RE: Application to Partially Sever and Transfer (ST Application) Certificate of Water Right No. 3696.0002 (Application No. A-3906.0003).

In response to the letter issued by ADWR dated August 23, 2022. Please find Bonita Creek Water Company responses to questions regarding our water intake and the need for a system to help prevent our intake from becoming inoperable.

PHOTO OF CURRENT BONITA CREEK WATER COMPANY INTAKE

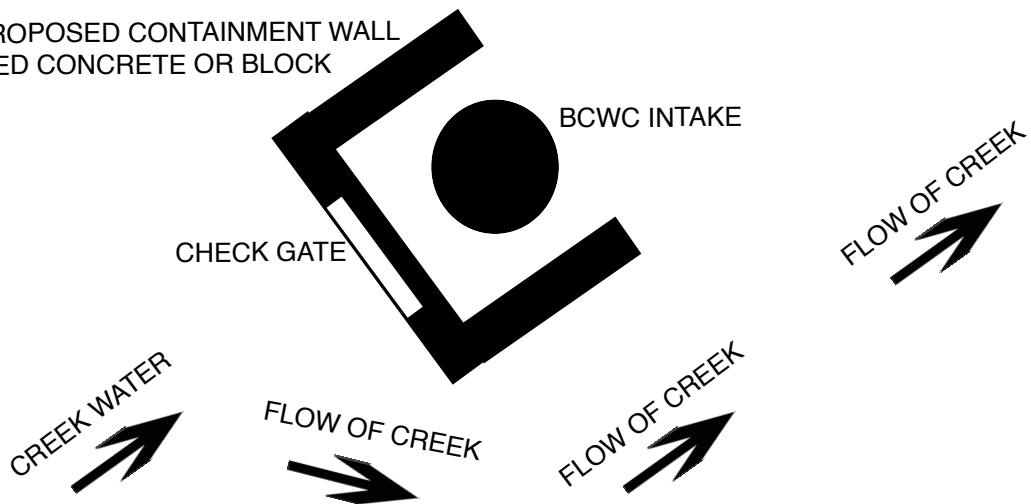
1. **Item 14** – Location of Point of Water Diversion (see Attachment 3 – Information Regarding Proposed Transfer) states: “The BCWC will divert appropriable water at a point along Bonita Creek located in the NW1/4 SW1/4 Section 32, T12N, R11E.” Additionally, the application describes “BCWC diverting appropriable water of Bonita Creek and/or withdrawing water from wells adjacent to Bonita Creek to deliver to its water customers.” Your E-mail indicates that the current diversion structure is either damaged or non-operational.

- (a) *Please confirm if the current diversion structure is intended to be the point of diversion as indicated on the Amended Application. If there will be a change or addition to the proposed diversion(s) and the location(s) of the point(s) of diversion, please provide the respective locations and nature of the diversion(s). If you plan to modify the current diversion, please detail the nature and extent of that modification with relevant documentation (if possible).*

1a) Our current diversion structure will remain as described in the Amended Application. Regarding additions to the existing diversion point, we would like to add two pieces. 1) A check gate, as seen in attached photo, that would be placed near our intake to help regulate the water we pump when creek is muddy, has high organics, snow season, etc. See illustration on last page. 2) A small concrete/block containment wall that would encompass the check gate and surround 3 sides of our pump intake, so to prevent debris from entering our intake. The creek flow would not be disturbed and would continue to flow around the added containment wall and intake as it does today. This would all need to be engineered.

1b) Our intake is operational. The reason for the request is that we have great difficulty when storms arise, which are often and unannounced. When debris of all kinds come rushing down the creek it jams up our intake. We rely on volunteers with the hopes of track-hoe machinery to dislodge large branches, logs, boulders and accumulated silt to free up the intake to pump again.
